PSEG Public Service
Electric and Gas
Company

August 28, 1984

HOPE CREEK GENERATING STATION
DOCKET NO. 50-354
CONTAINMENT ISOLATION

Pursuant to discussions with L. Ruth, Containment Systems Branch, on July 2 and 12, 1984, FSAR Sections 1.10 and 6.2, Tables 1.11-1, 6.2-16 and 6.2-25, Figures 5.4-8, 6.2-28 and 6.2-45, and Question 480.14 have been revised and are attached for your use. These changes will be incorporated into Amendment 8.

FIGURE 6.2-38
SHEET 3 OF 48

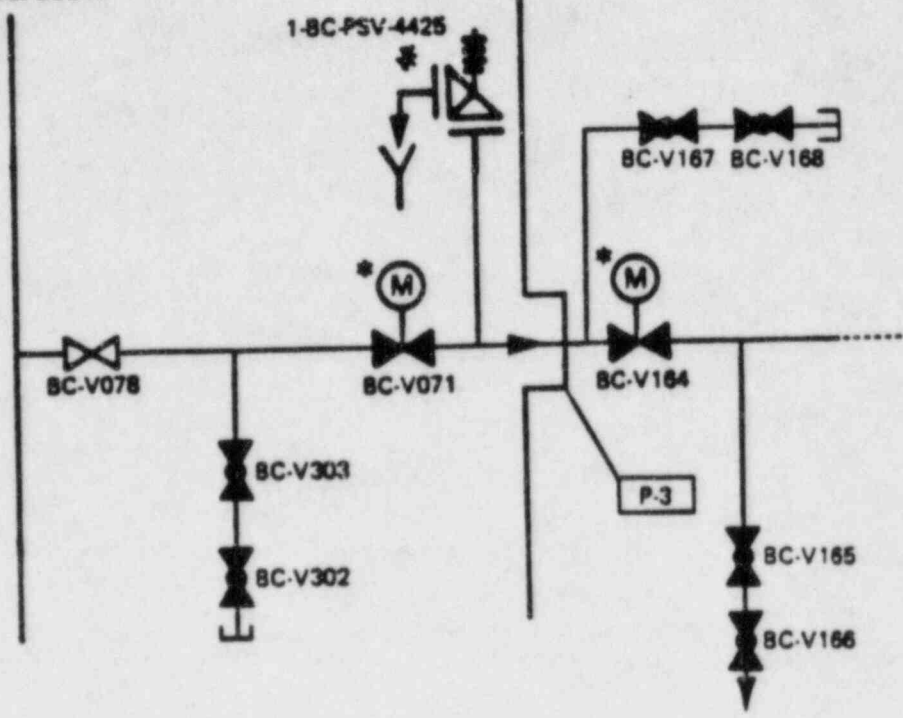
The residual heat removal (RHR) shutdown cooling suction line penetrates primary containment and taps into one of the two recirculation loops. Isolation is provided by two normally closed motor-operated gate valves, which are maintained closed by a containment isolation signal. One containment isolation valve is located inside primary containment, and the second valve is located outside primary containment. ~~This design is conservative since it does not take credit for the RHR system being a closed system outside primary containment.~~

FIGURE 6.3-28
SHEET 4 OF 48

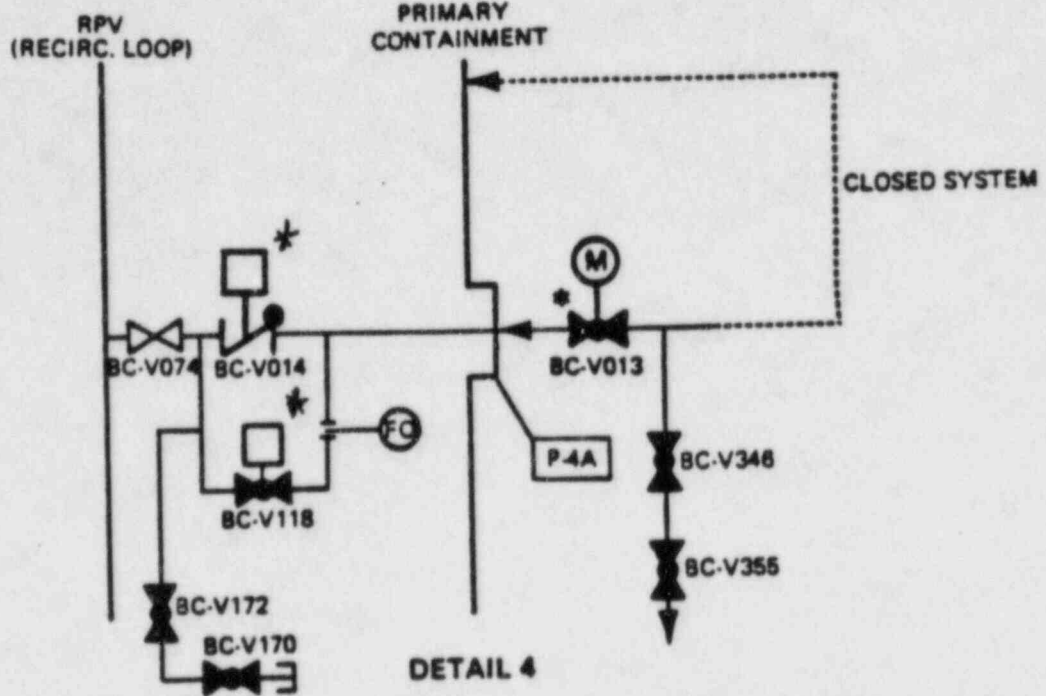
The RHR shutdown cooling return lines ^{connect to} penetrate the primary containment and ~~discharge into~~ ^{are connected to} the discharge side of each recirculation loop, which ~~injects directly into~~ the RPV. Each line is isolated by a single, normally closed, motor-operated primary containment isolation valve ~~that receives a containment isolation signal outside primary containment~~ and by a testable check valve inside primary containment. ~~The motor-operated~~ Use of a single containment isolation valve is justified on the basis that the RHR system meets the requirements of a closed system outside primary containment. The RHR system is maintained in a leak-tight condition during normal operation by the use of a jockey pump system and by pump room flooding alarms and periodic visual inspection.

Each testable check valve is ^{provided} ~~provided~~ with a bypass line for testing purposes. These lines are isolated by an air-operated ^{fail closed} globe valve.
